DEVELOPMENT APPLICATION ASSESSMENT REPORT

Application Number:	DA2021/1189
----------------------------	-------------

Responsible Officer:	Thomas Burns
Land to be developed (Address):	Lot 103 DP 860197, 73 McCarrs Creek Road CHURCH POINT NSW 2105
Proposed Development:	Alterations and additions to a Dwelling House
Zoning:	E4 Environmental Living
Development Permissible:	Yes
Existing Use Rights:	No
Consent Authority:	Northern Beaches Council
Land and Environment Court Action:	No
Owner:	Debra Fei Charlton Christopher John Charlton
Applicant:	Brent Gasson

Figure 1: area above 8.5m height plane

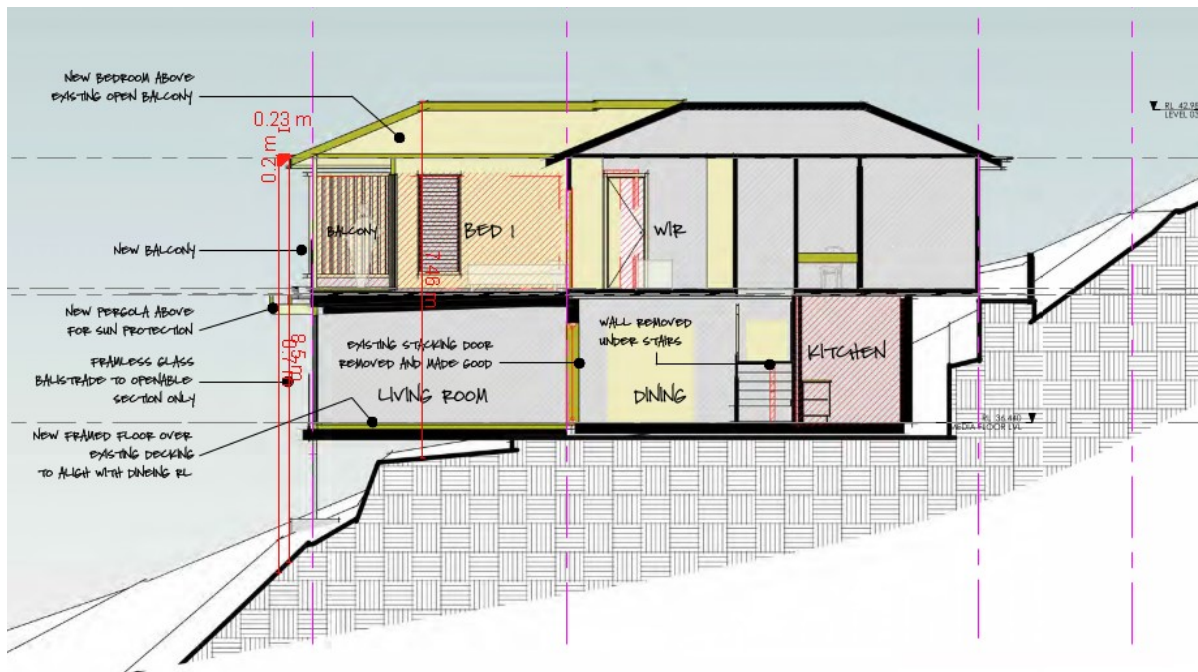
The area above 8.5m is minor and confined to the gutter of the first floor. The horizontal width of the non-compliance is 0.23m and the breach represents a height of 0.2m. Figure 1 depicts the extent of the non-compliance.

Figure 1: north-eastern elevation envelope breach

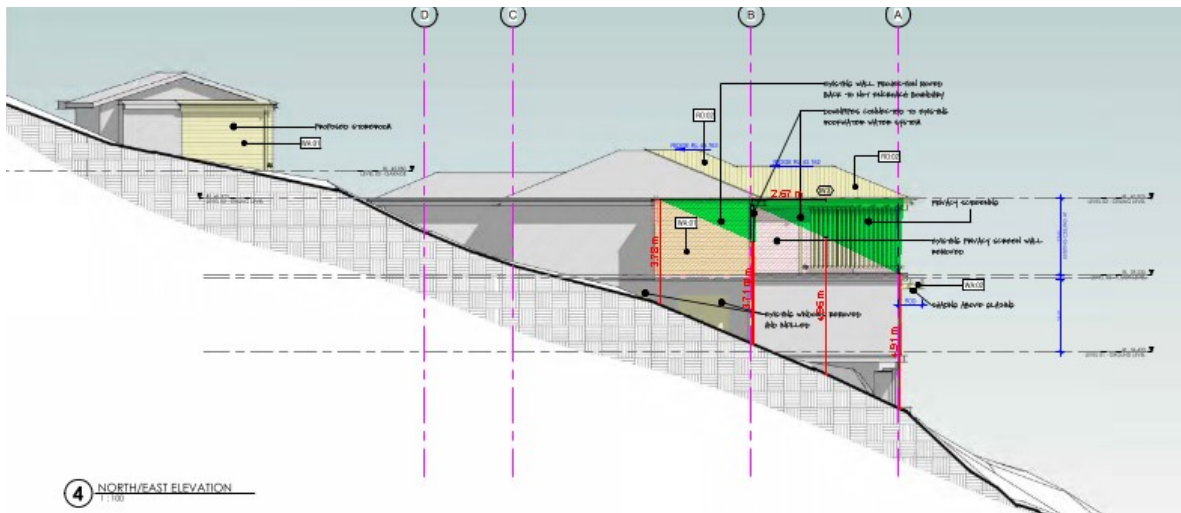
The extension to the first floor protrudes outside of the prescribed building envelope along the north-eastern elevation. The breach occurs for a portion of the first floor and occurs between a height of 0.01m - 2.46m, which represents a variation up to 50.1% from the numeric requirement. Figure 2 below depicts the extent of the numeric non-compliance.

Notwithstanding, the control permits a variation provision which states that the building envelope assessment will be subject to a merit assessment where the building footprint is situated on a slope over 30%. The site topography directly under the building footprint has a 33.56% and therefore, the proposal is subject to a merit assessment.
